VSP-75

VENDOR SERVICE PUBLICATION

SUBJECT: Avco Lycoming Service Letter No. L218 and Service Instruction No. 1059C, No. 1110C and No. 1257E

Typical Adapter Installation

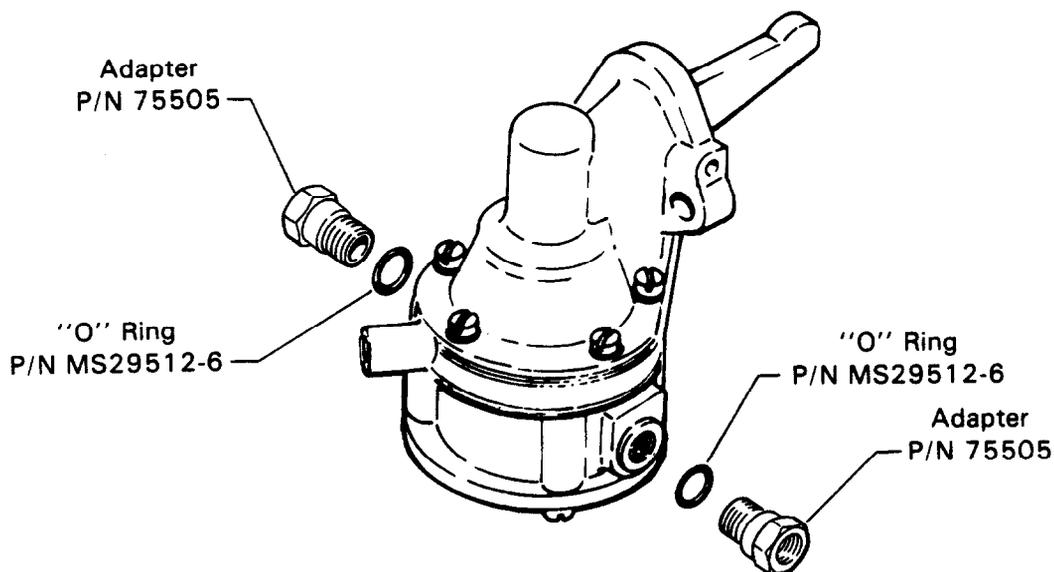
When replacing certain older AC diaphragm type fuel pumps, AC P/N 40174 or P/N 56999 (tapered pipe thread inlet and outlet ports) with a new pump incorporating straight thread ports, an adapter P/N 75505 is available to adapt the pipe thread fittings to the new pump. All newer types of fuel pumps incorporate straight thread ports.

When the older model fuel pumps are replaced with new models, 2 Adapters P/N 75505 and 2 "O" Rings P/N MS29512-6 (one for each adapter) must be ordered separately for proper installation.

Figure 1.
Carburetor Showing Area to be Machined

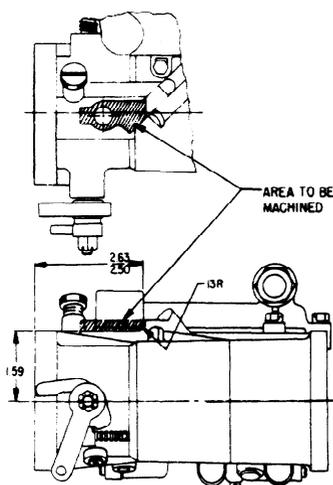
Because of the increased size of the new AC fuel pumps, certain engine models using P/N LW-16335 fuel pump with rear mounted carburetors must have the carburetor reworked to remove the back suction economizer boss. (If not already accomplished or prior to installation of new P/N LW-16335 fuel pump.) See Table 1. Using suitable equipment machine this boss as shown in Figure 1. Also, because of the increased size of the new fuel pump, certain dual magneto engine models must have the accessory housing reworked. See Table 2. Again, using suitable equipment, machine the boss on the accessory housing as shown in Figure 2.
